MEMORANDUM

TO: District of Columbia Board of Zoning Adjustment

SUBJECT: BZA Case No.18772A, 627 H Street, N.W.

Figure 1. Roof and Penthouse Plan Approved in BZA 18772

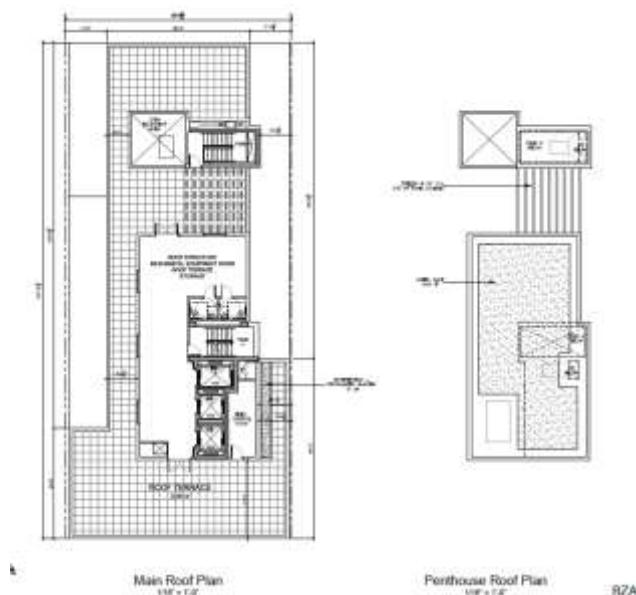
The approved penthouse would have had two 18'6" high sections joined by a trellis into one roof structure that complied with all setback requirements. The southern section would have included common space related to rooftop recreation, but no habitable space. The northern section would have contained secondary egress stairs from the roof terrace and mechanical equipment open to the sky.

Figure 1. Proposed Roof and Penthouse Plan

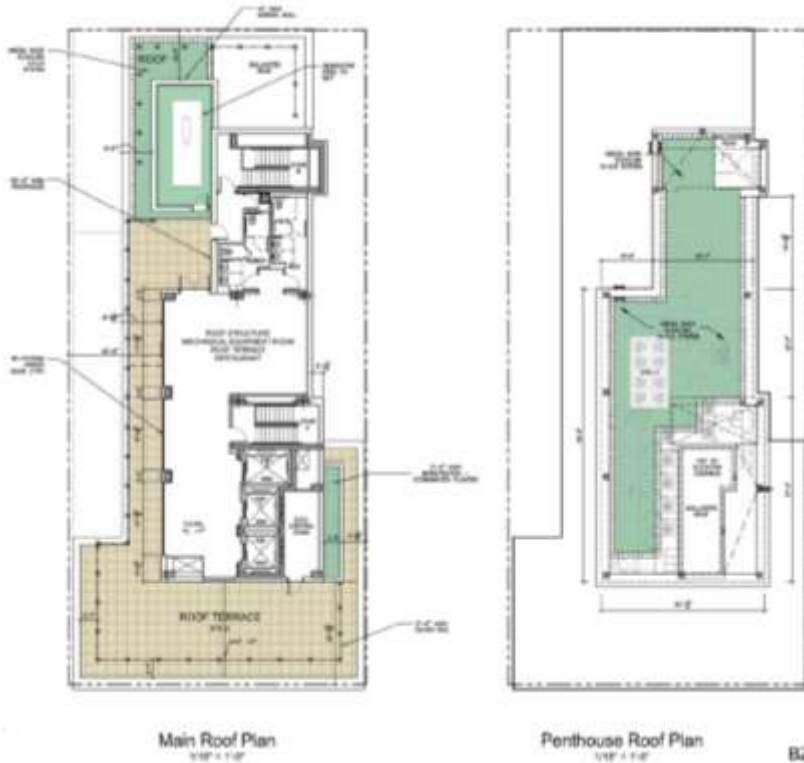
The proposed penthouse would be 18'6" tall, except for the mechanical area at the northwest corner of the building, where it would be 10' high. Two heights are permitted by the now-applicable penthouse regulations. It would meet setback requirements on the north and south. The east setback would be identical to what was approved in Order 18772. The west penthouse wall is now proposed to be setback at a greater, but still nonconforming, 1 to 1.66 ratio, rather than the 1 to 3 ratio permitted by the approved variance.
